Littleton King Street Common Phase 1 Retail Development - Peer Review

December 15, 2025

Review by Utile Architecture and Planning

Building-Specific Scale Comments: Building 1100

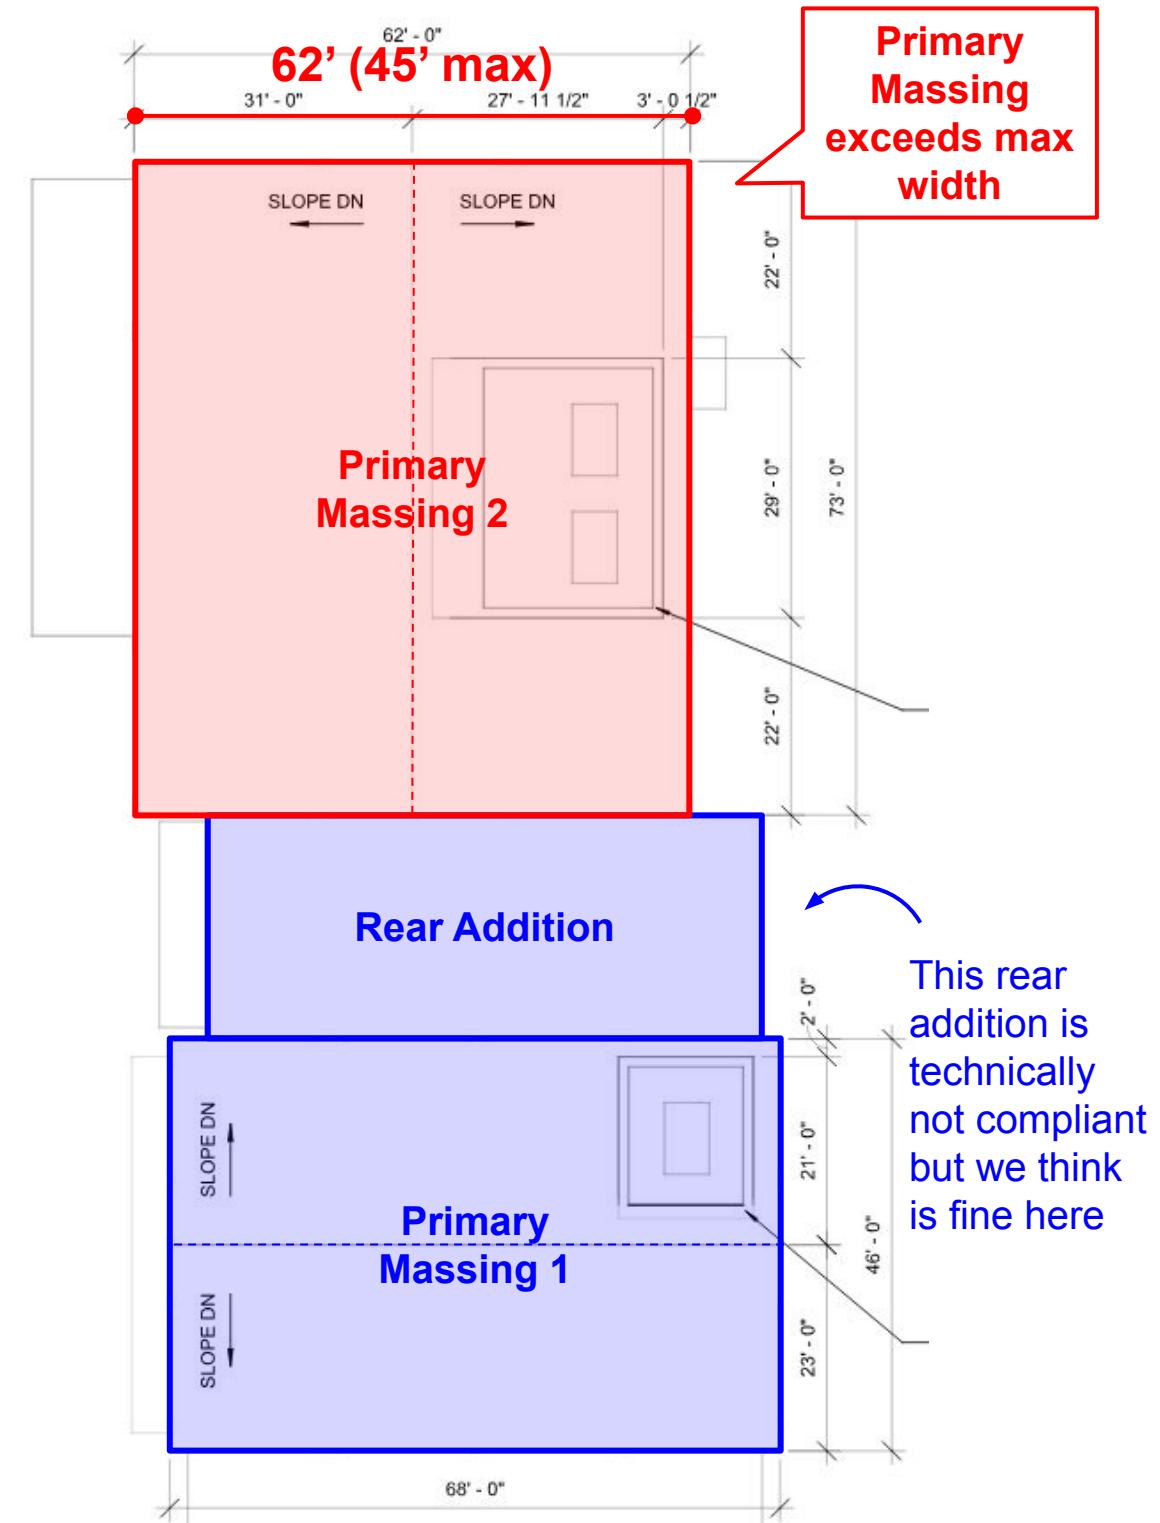
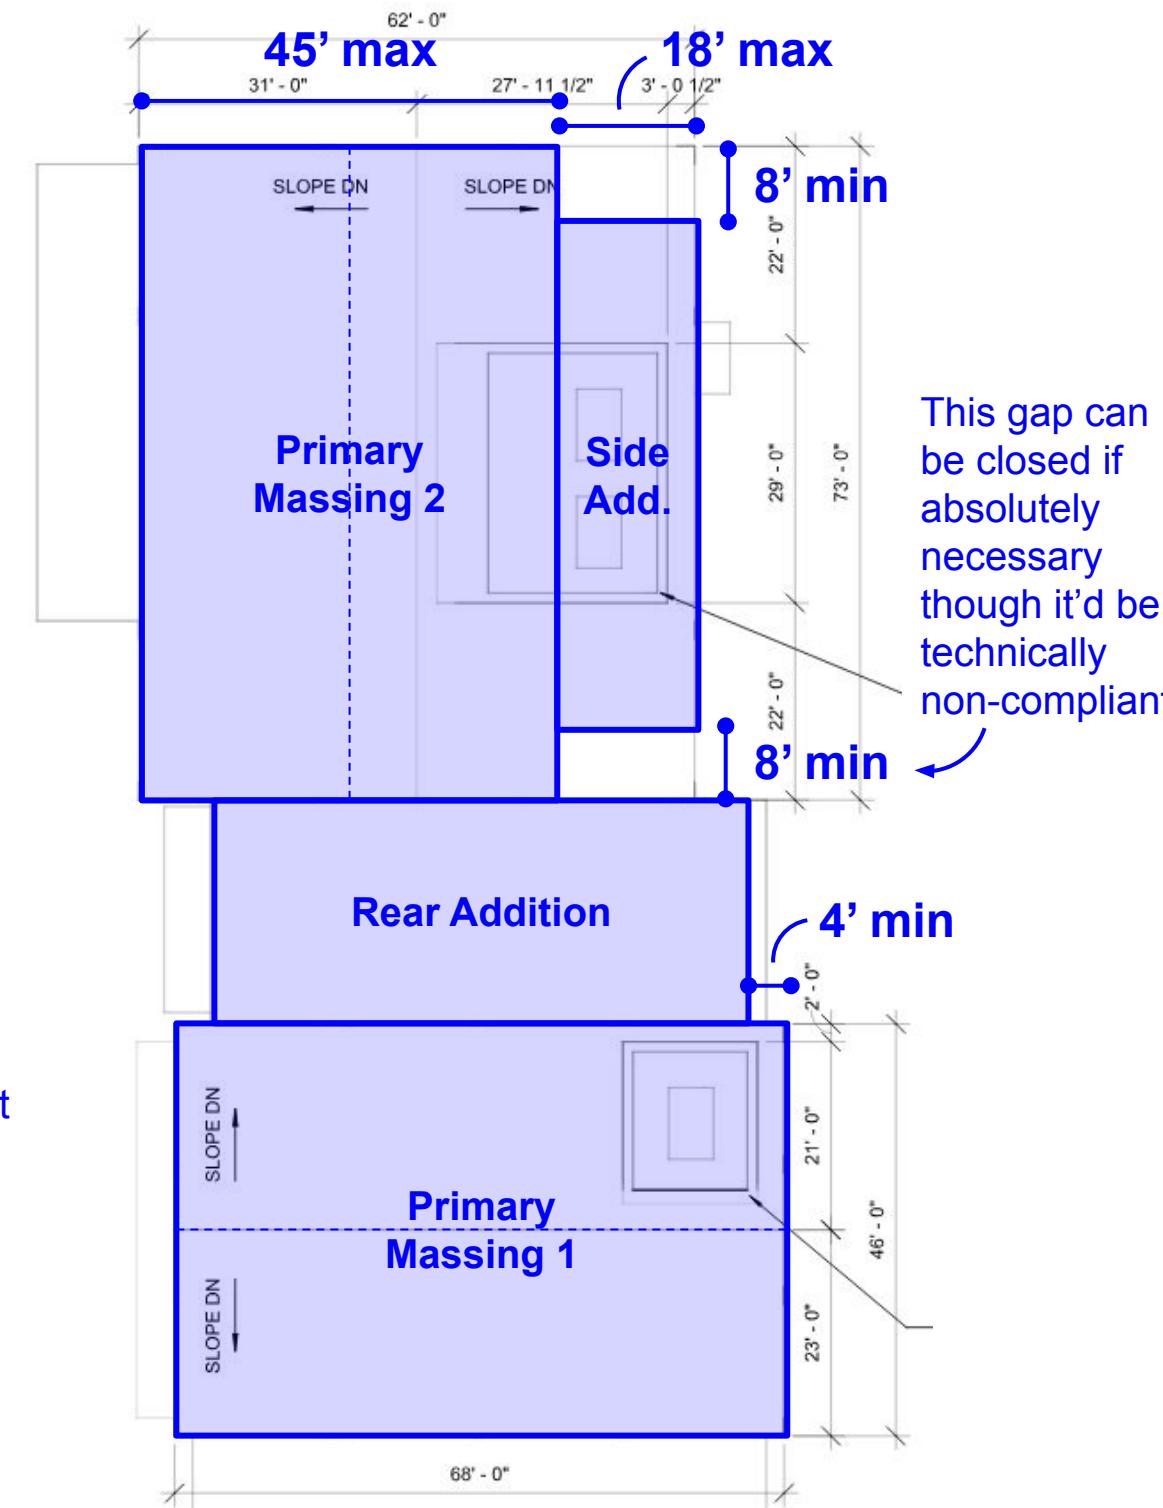
Building 1100's north primary massing's width exceeds the maximum (62' vs 45' max). The maximum width is to ensure that buildings do not appear oversized, gable slopes are appropriately pitched (i.e., not too shallow), and the building assembly is a consistent whole.

(§173-221.K. General Building Standards Primary Massing)

As mentioned earlier, reducing the perceived building scale does not necessarily mean a significant reduction in the total building area / footprint – there are multiple options to create an assembly out of primary massing(s) and building component(s) that retain most/all of the area (see one example at right). (§173-221.M. Example Massing Combinations)

Building-Specific Scale Comments: Building 1200

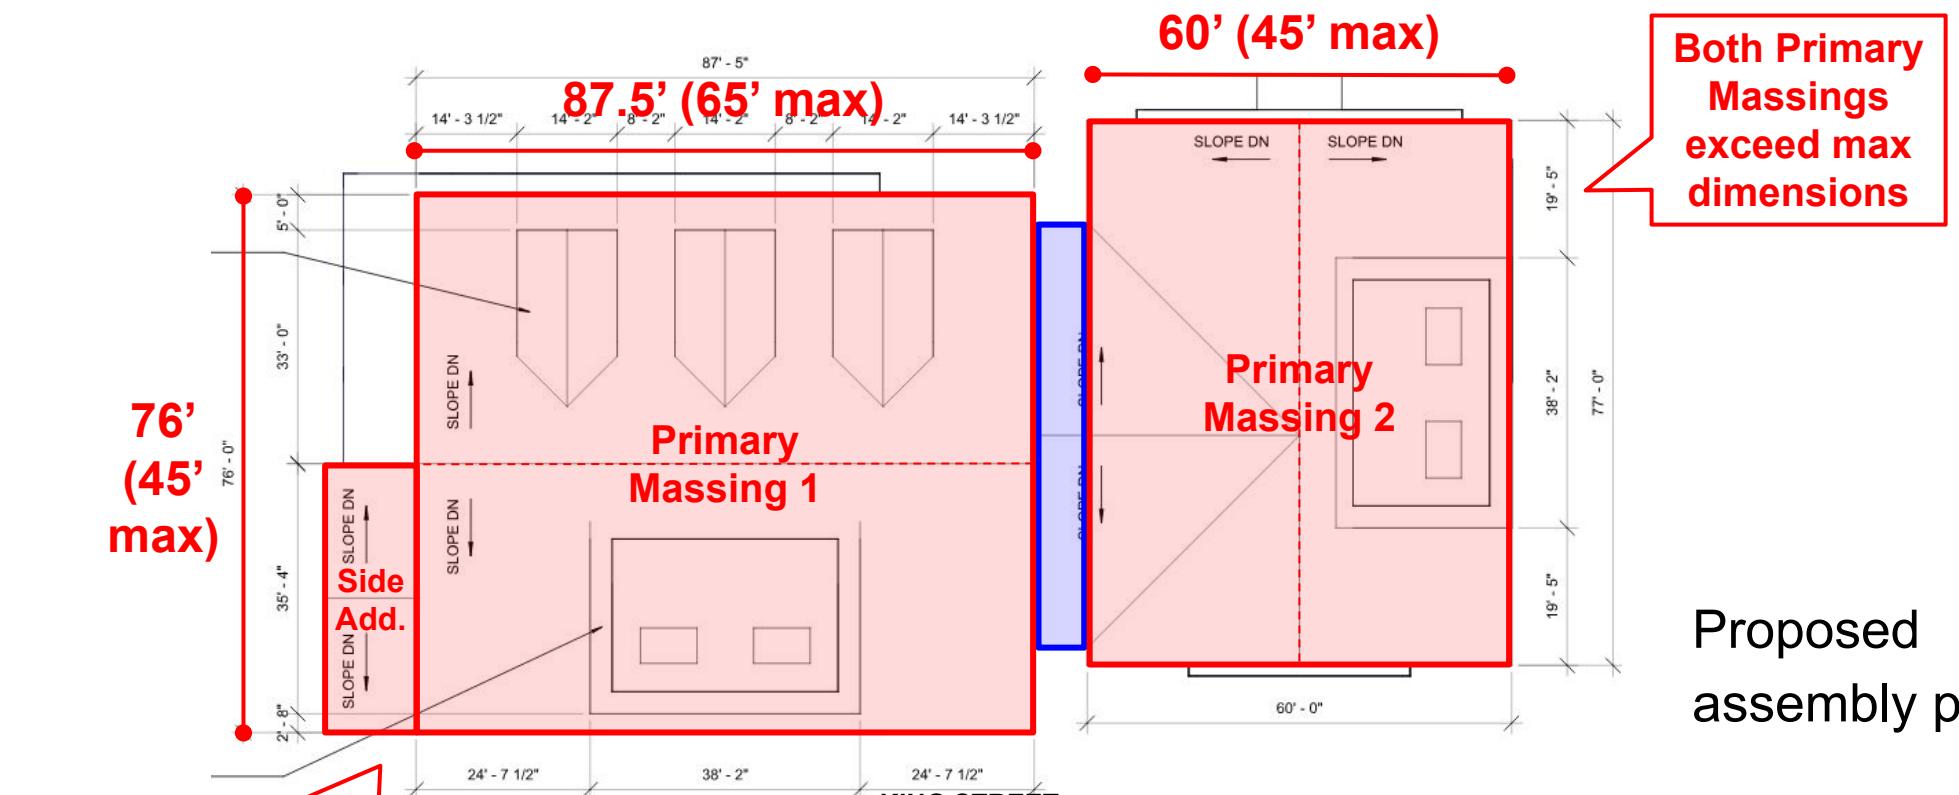
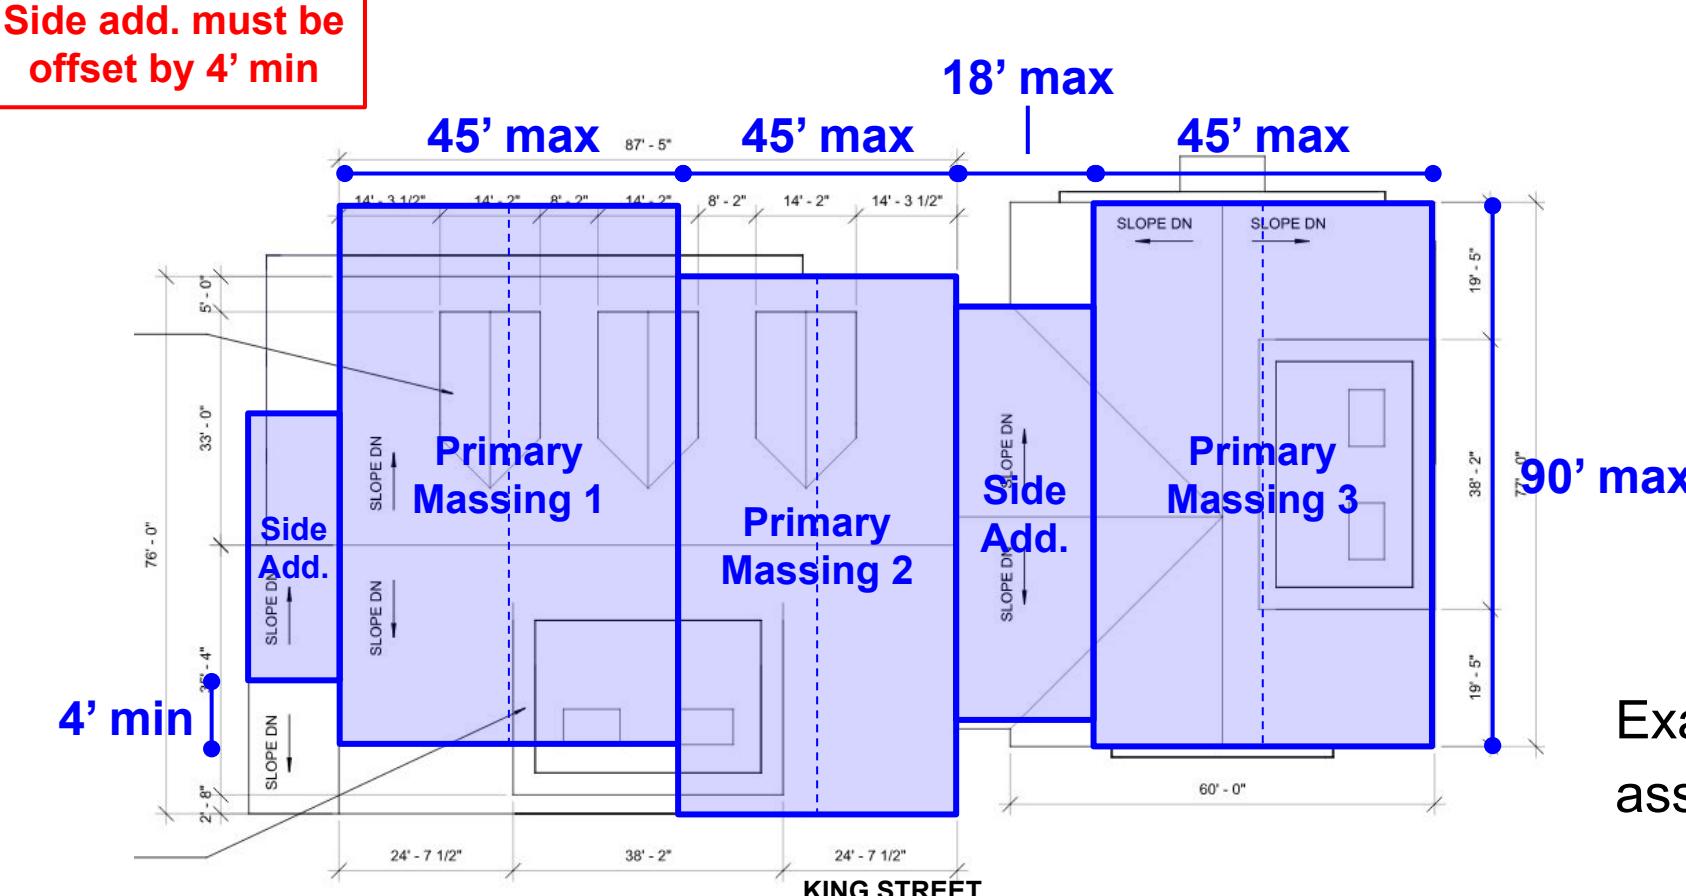
Building 1200's two primary massings both exceed the maximum allowable dimensions. The east primary massing is 87.5' wide by 76' deep, equalling an area *more than double* the allowable maximum for a single primary massing (65' wide by 45' deep, when the long side is oriented parallel to the ROW), resulting in an oversized building. (§173-221.K. General Building Standards Primary Massing)

As mentioned earlier, reducing the perceived building scale does not necessarily mean a significant reduction in the total building area / footprint – there are multiple options to create an assembly out of primary massing(s) and building component(s) that retain most/all of the area (see one example at right). (§173-221.M. Example Massing Combinations)

Building-Specific Scale Comments: Building 1200

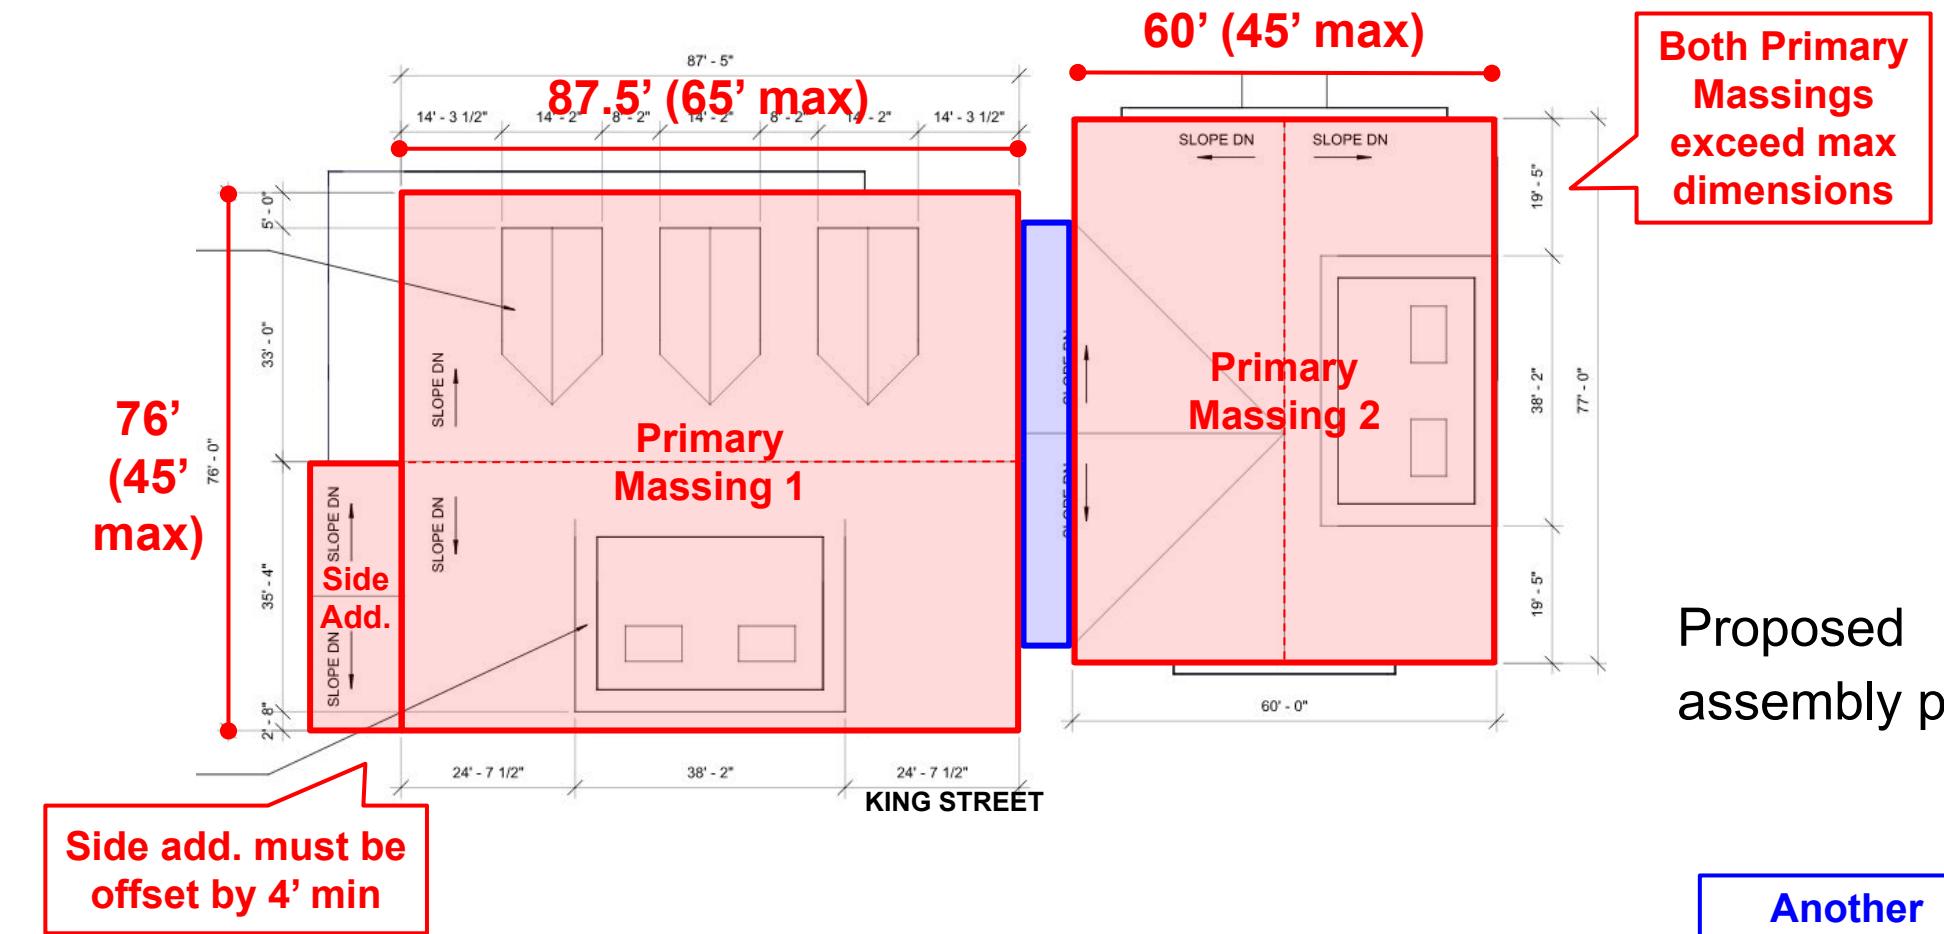
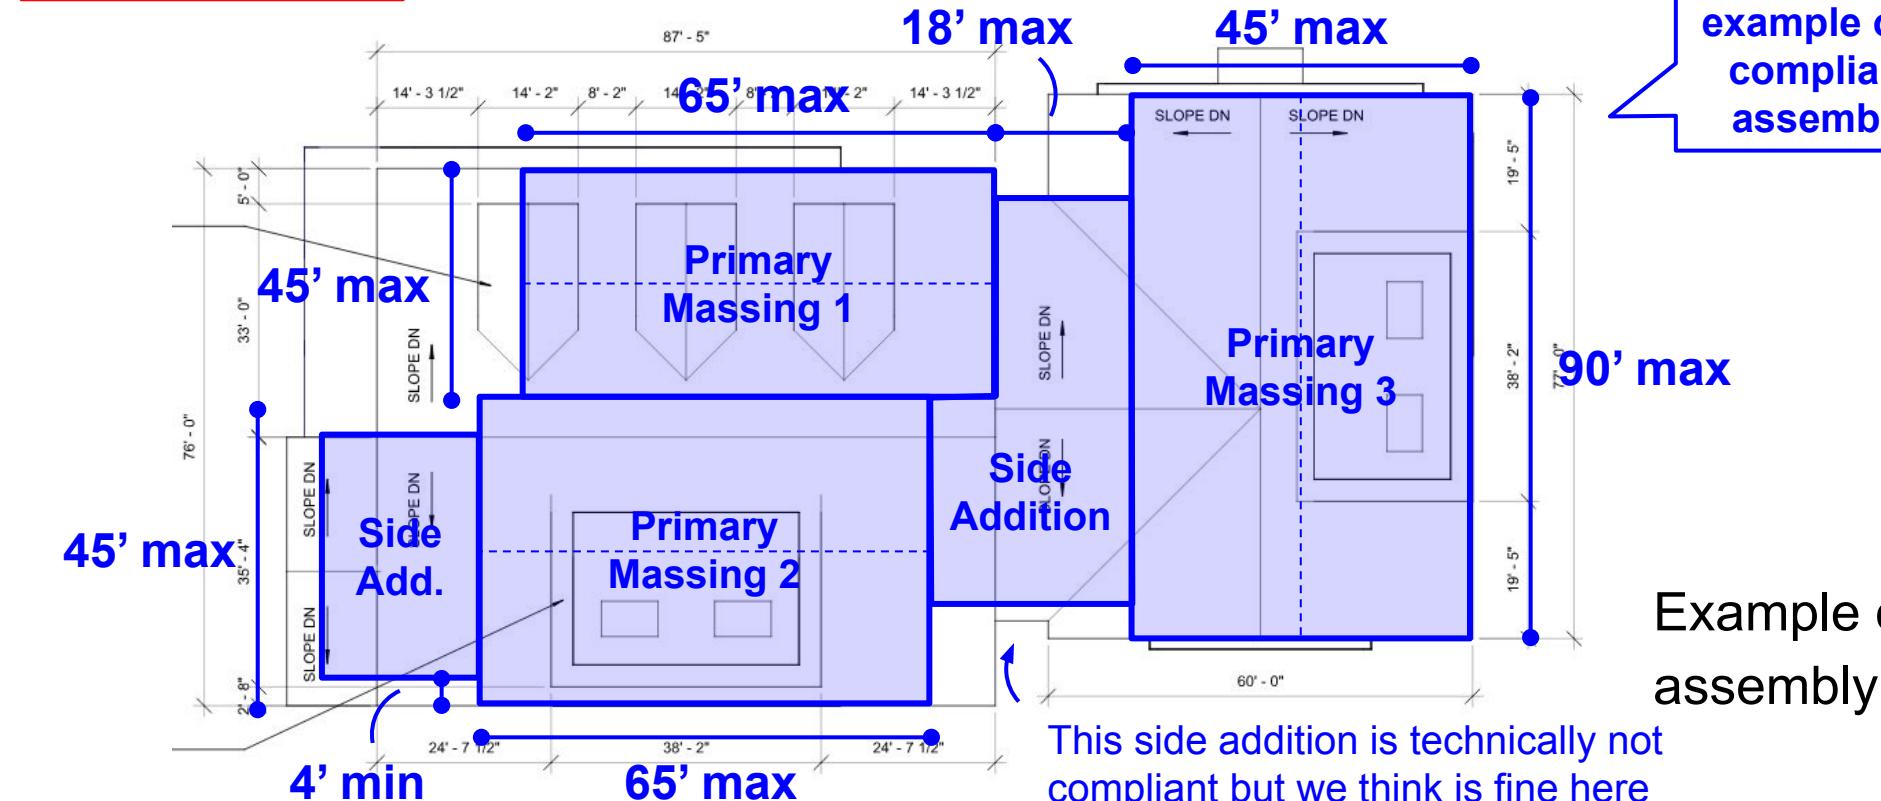
Building 1200's two primary massings both exceed the maximum allowable dimensions. The east primary massing is 87.5' wide by 76' deep, equalling an area *more than double* the allowable maximum for a single primary massing (65' wide by 45' deep, when the long side is oriented parallel to the ROW), resulting in an oversized building. (§173-221.K. General Building Standards Primary Massing)

This side addition is technically not compliant but we think is fine here

As mentioned earlier, reducing the perceived building scale does not necessarily mean a significant reduction in the total building area / footprint – there are multiple options to create an assembly out of primary massing(s) and building component(s) that retain most/all of the area (see one example at right). (§173-221.M. Example Massing Combinations)
